Amendments to the Drawings:

Included in the amendment and attached are an "Annotated Sheet Showing Changes" and a "Replacement Sheet" for Figs. 2I, 2J, 2L, 2M, 2N, 2O, and 2R.

SERIAL NO.: 09/997,133
PETER H. PRIEST (919-942-1434)

FIG. 2I

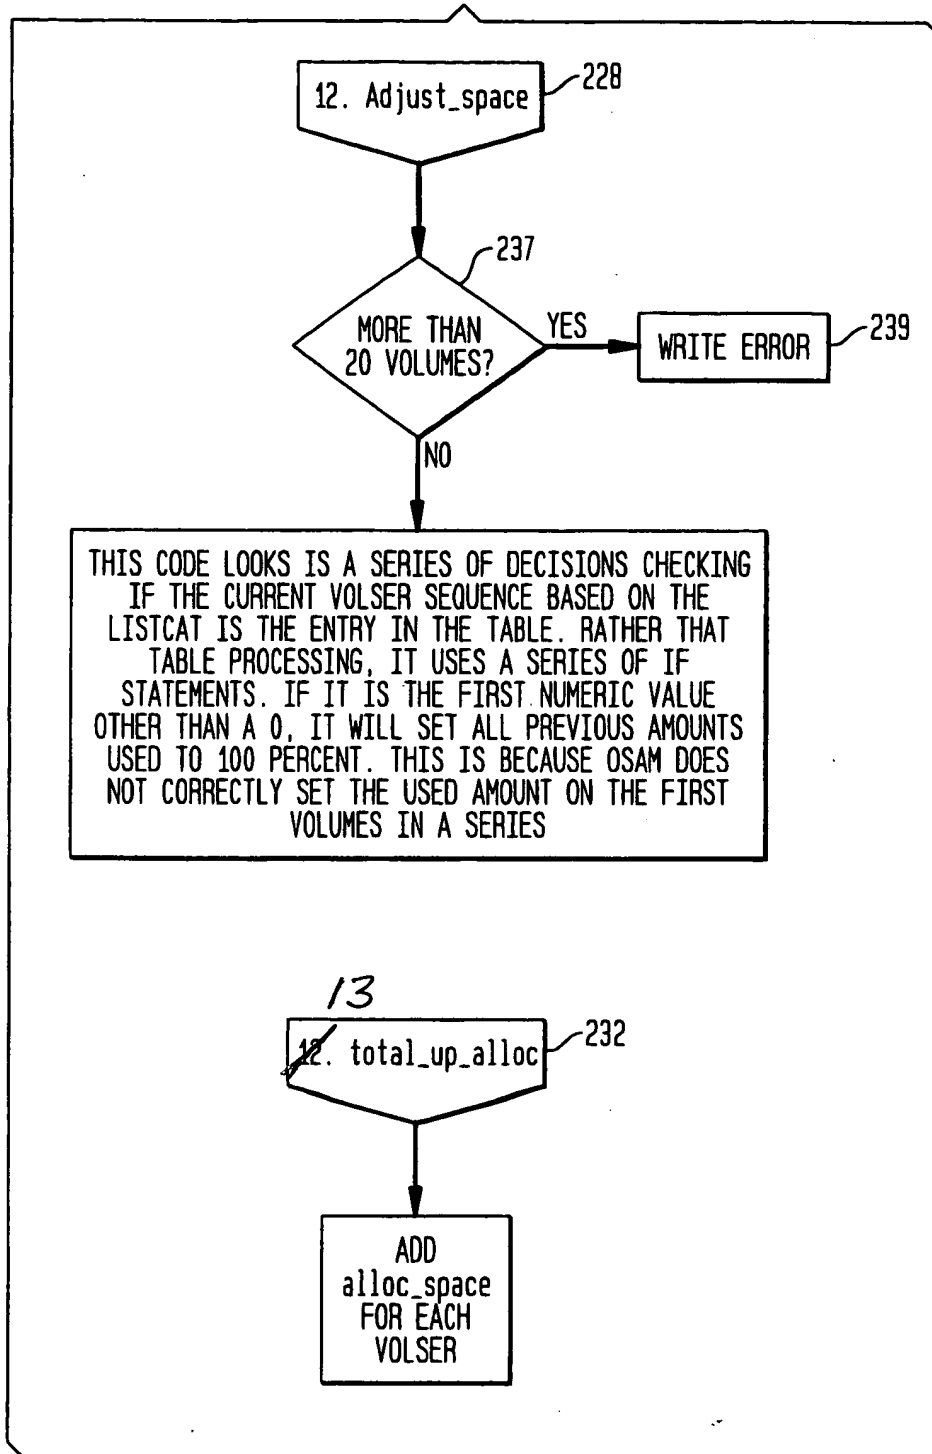
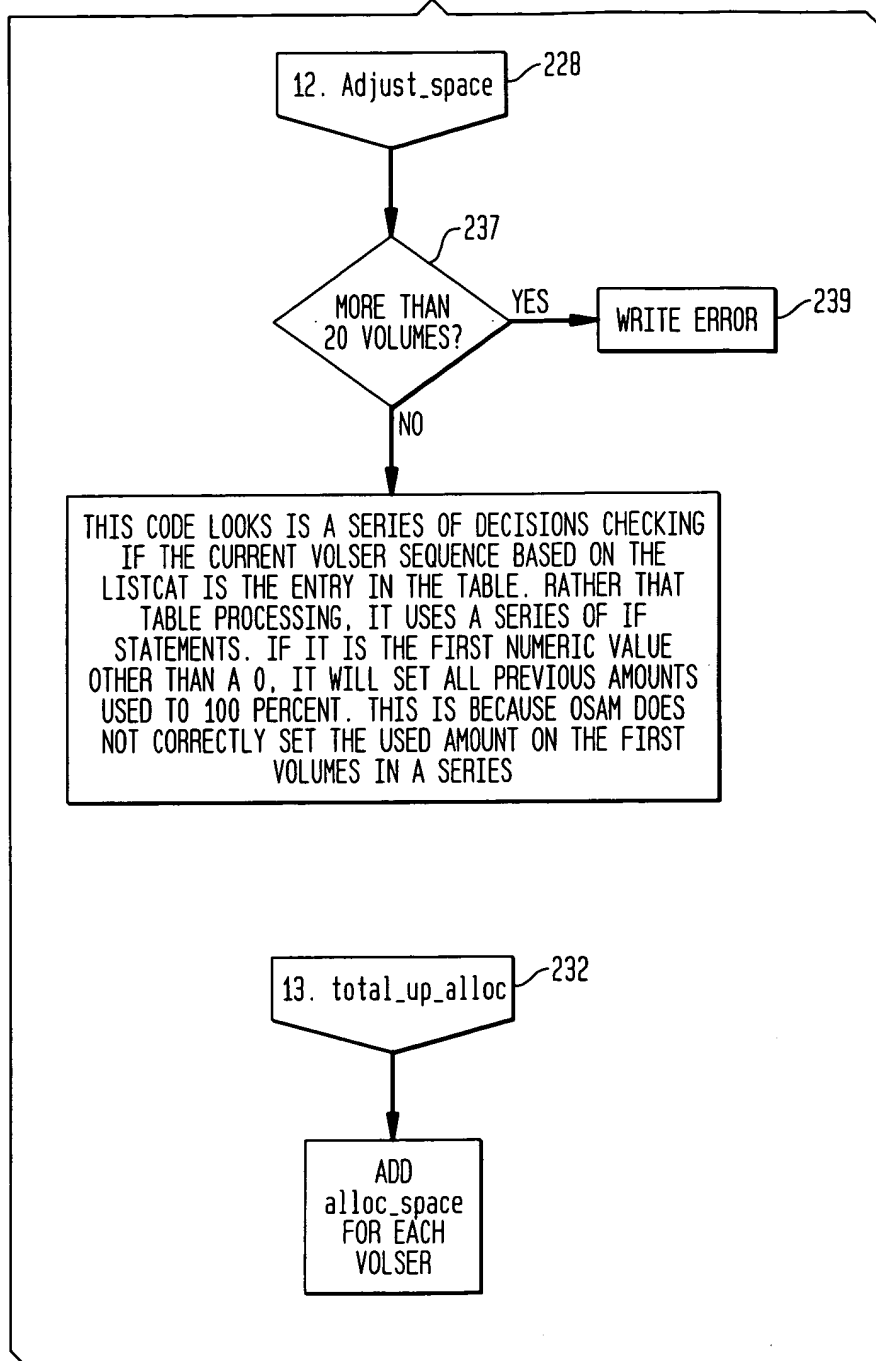
In Fig. 2I, the legend "12. total_up_alloc" on block 232 is corrected to "13. total_up_alloc" due to a duplicate number in the legends of block 232 and block 228 and changed to be consistent with the specification.

FIG. 2J

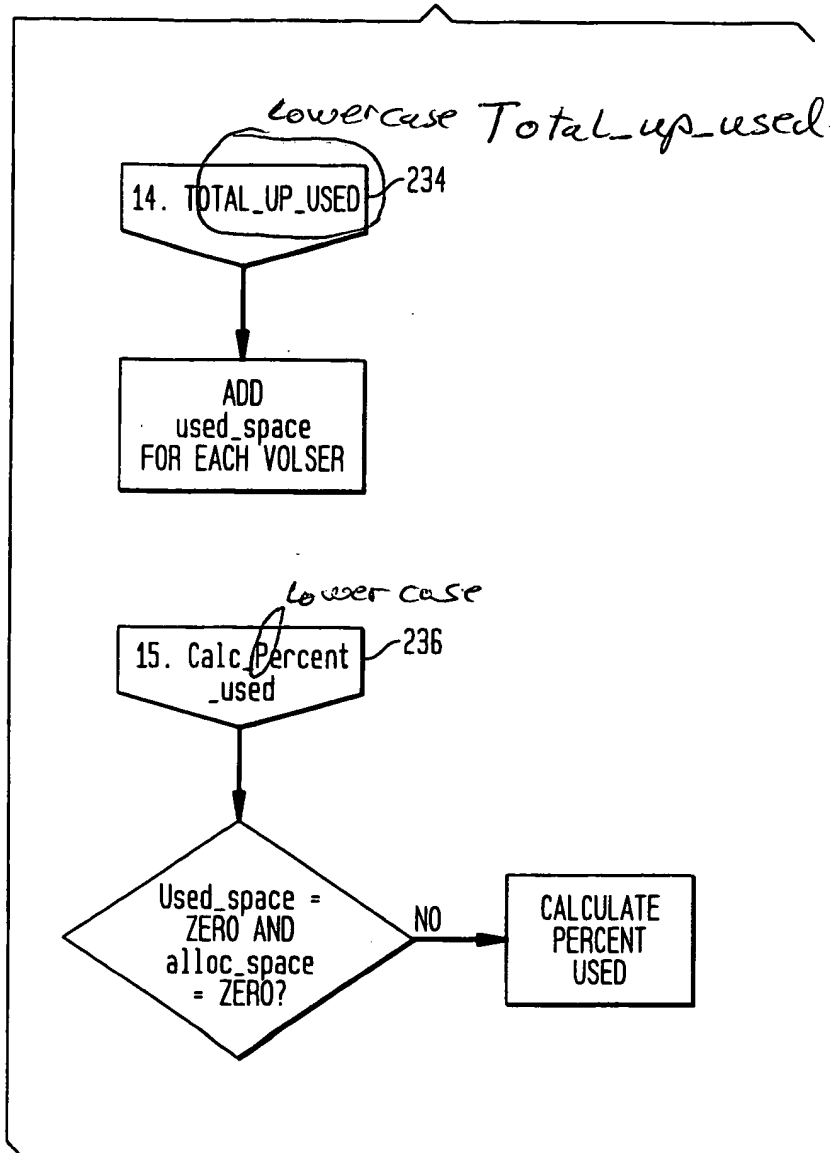
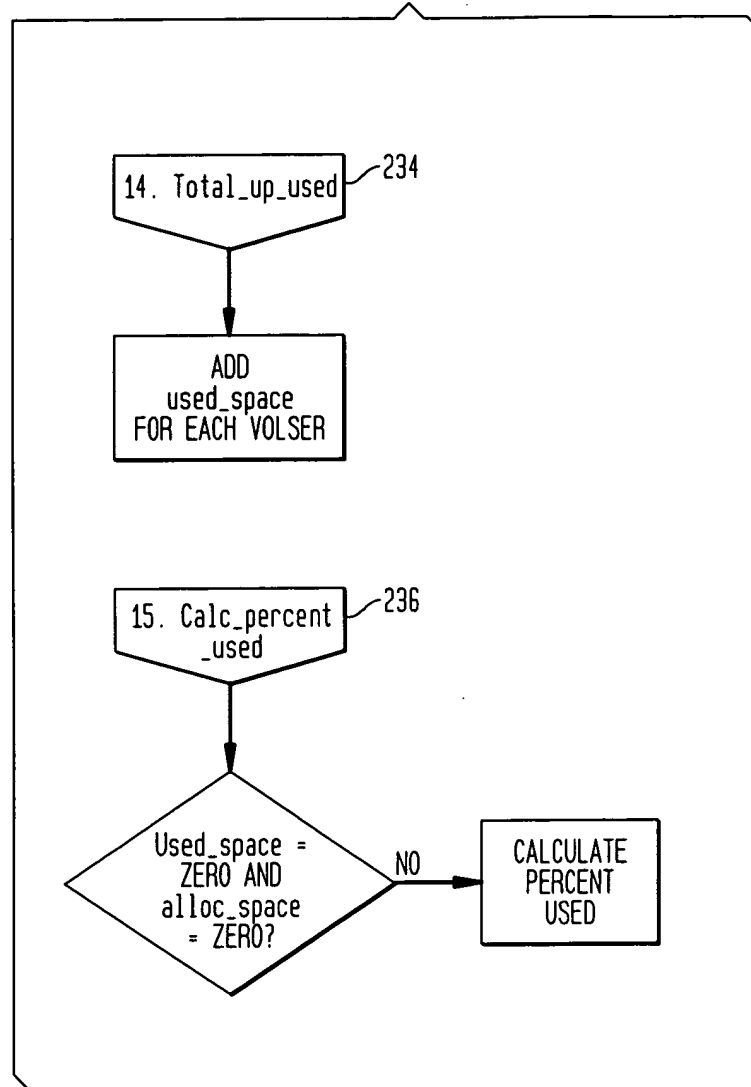
In Fig. 2J, the legend "14. TOTAL_UP_USED" on block 234 is corrected to "14. Total_up_used" to be consistent with the capitalization used in the specification. Also, the legend "15. Calc_Percent_used" on block 236 is corrected to "15. Calc_percent_used" to be consistent with the capitalization used in the specification.

FIG. 2L

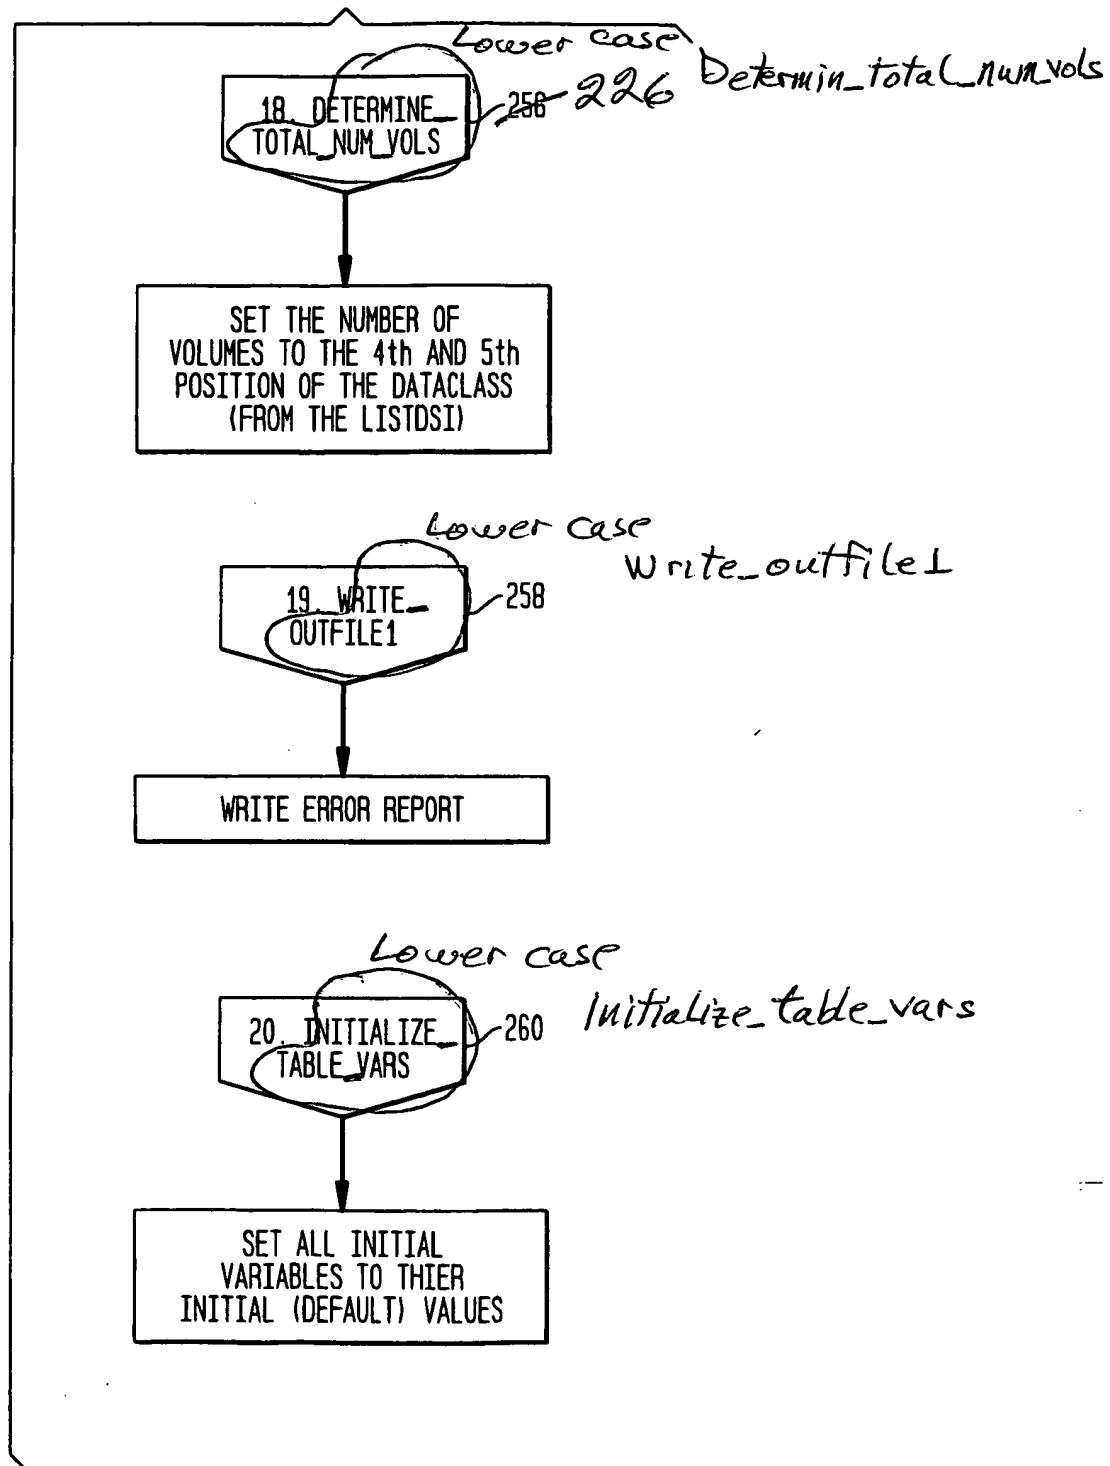
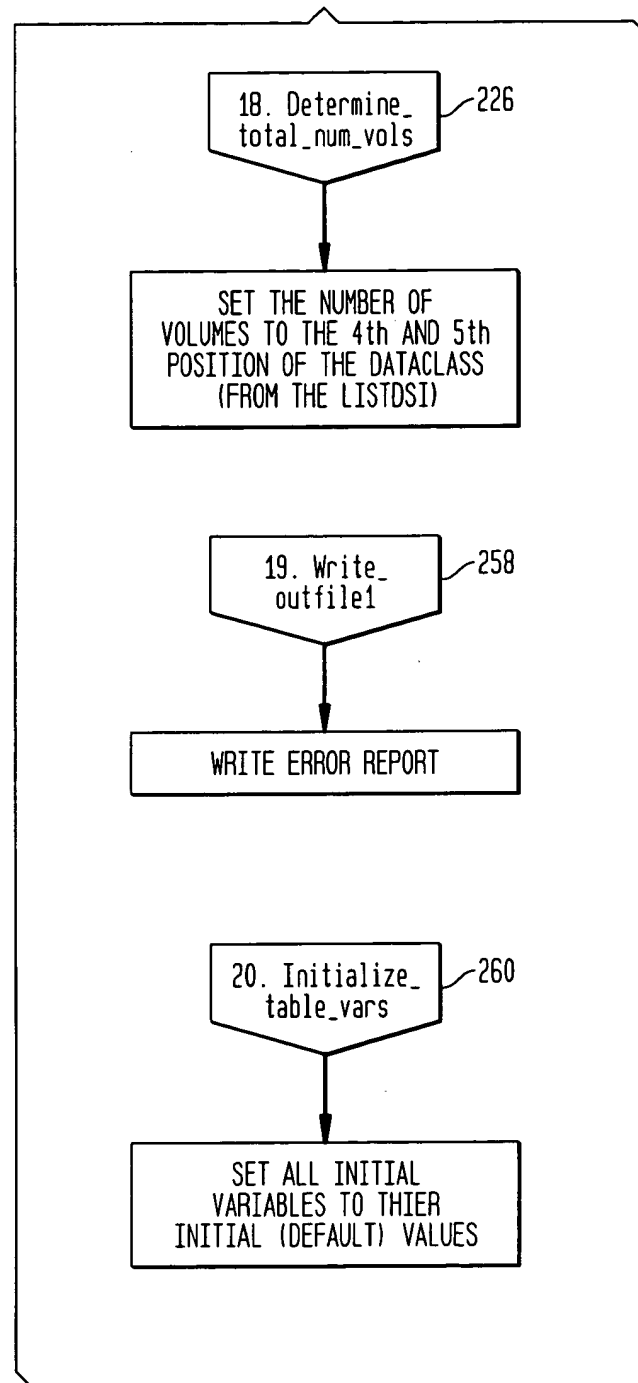
In Fig. 2L, the block reference number 256 is an incorrect reference number and is corrected to 226 to be consistent with the specification and drawings, for example, the reference to block 226 on page 10, line 20 and the reference to step 18 226 in Fig. 2C. In this same block, newly corrected to 226, the legend "18. DETERMINE TOTAL NUM VOLS" is corrected to "18. Determine_total_num_vols" to be consistent with the capitalization and name reference used in the specification. The legends on blocks 258 and 260 are corrected to be consistent with the capitalization and name reference used in the specification. The legend "19. WRITE OUTFILE1" on block 258 is corrected to "19. Write_outfile1". The legend, "20. INITIALIZE TABLE VARS" on block 260 is corrected to "20. Initialize_table_vars".

FIG. 2M

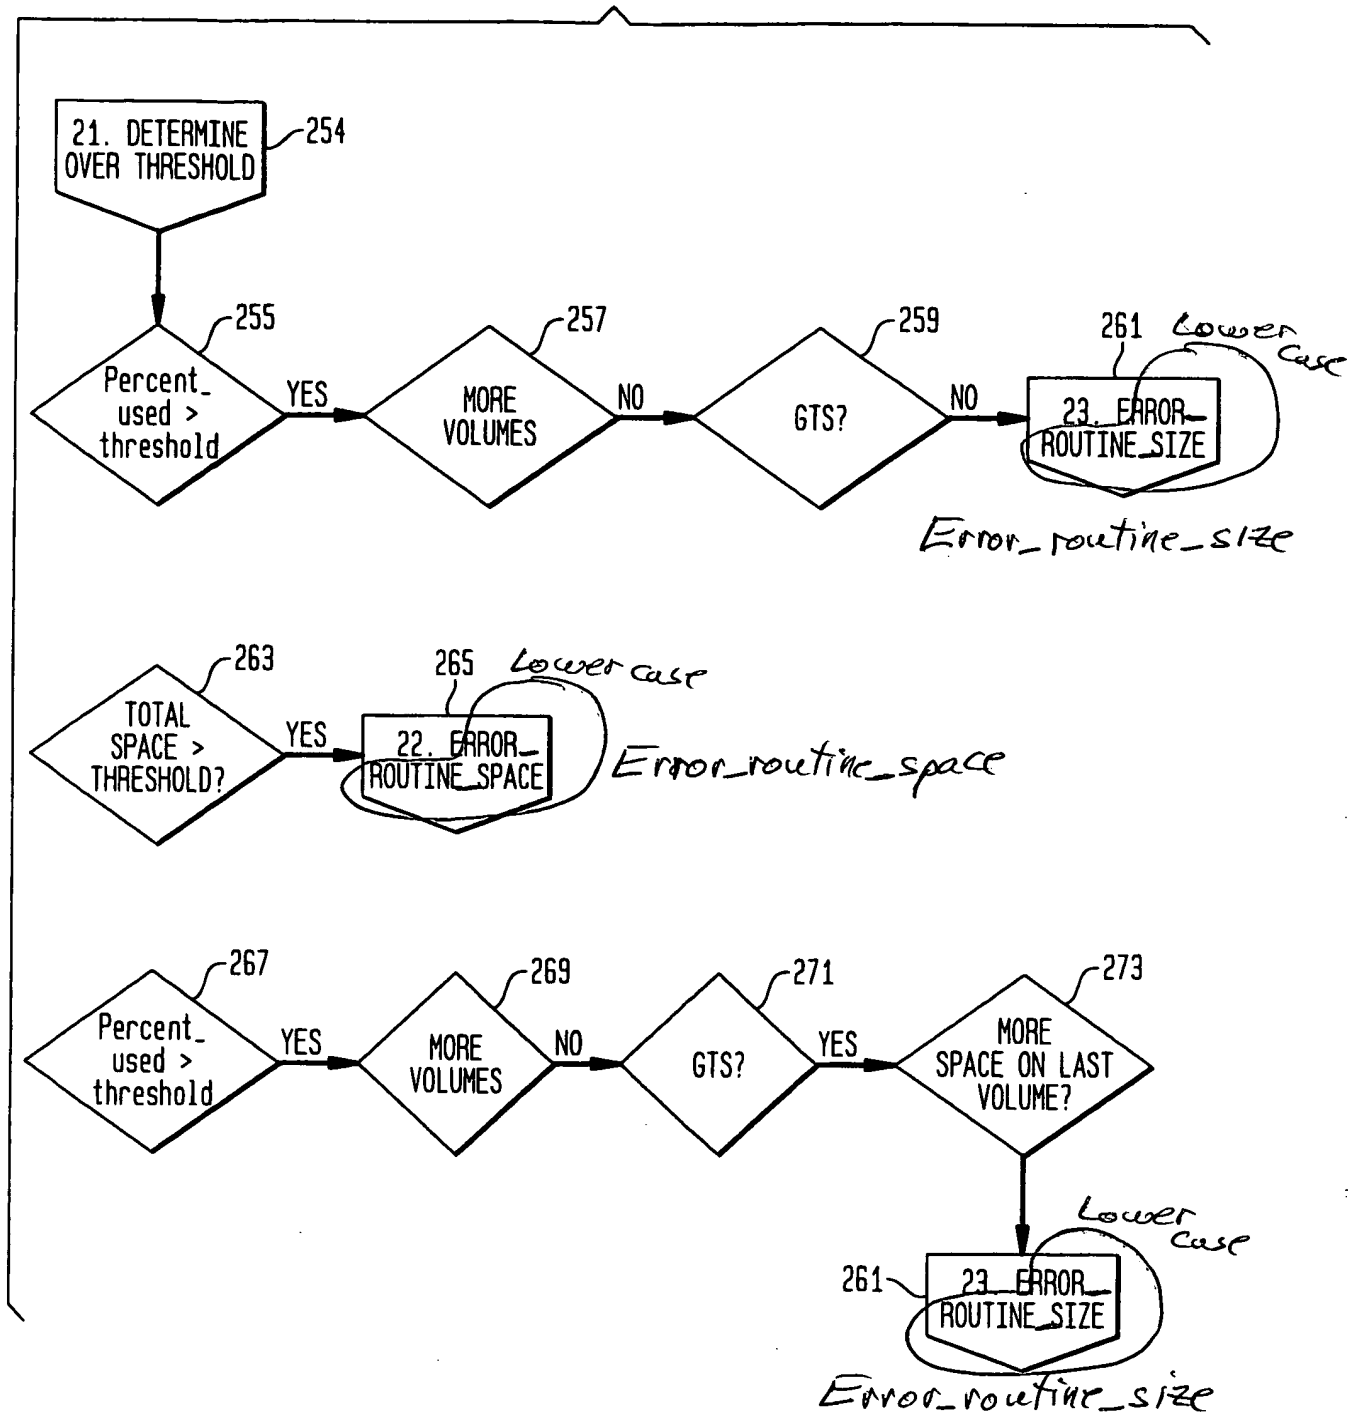
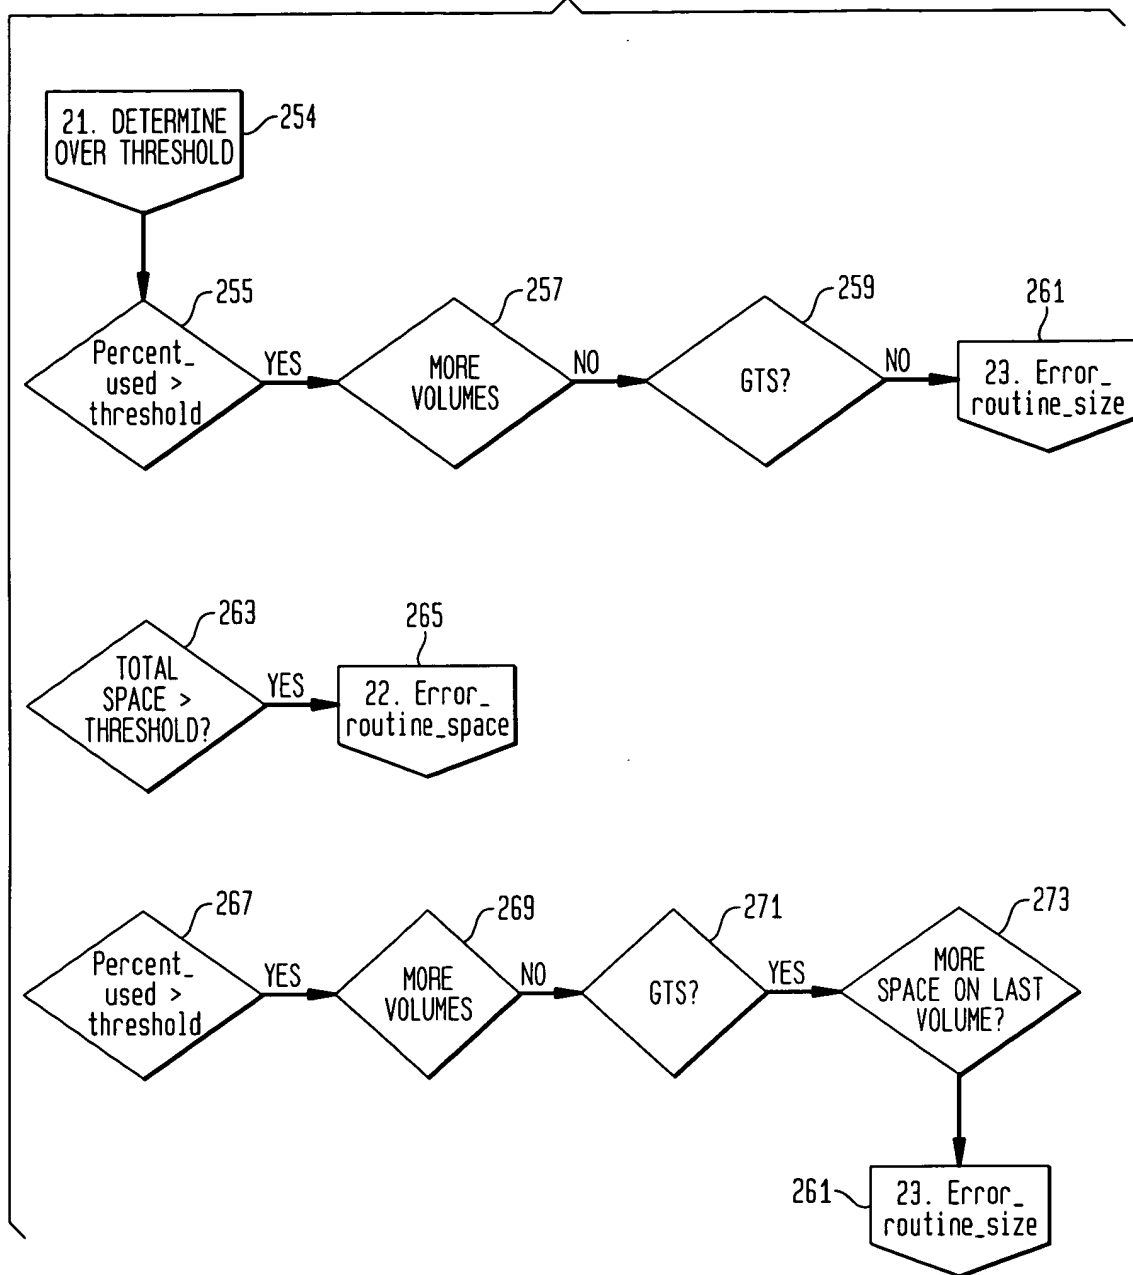
In Fig. 2M, the legends on blocks 261 and 265 are corrected to be consistent with the capitalization and name reference used in the specification and other drawings: On block 261, in

two places, the legend "23. ERROR ROUTINE SIZE" is corrected to "23. Error_routine_size".

On block 265, the legend "22. ERROR ROUTINE SPACE" is corrected to "22.

Error_routine_space".
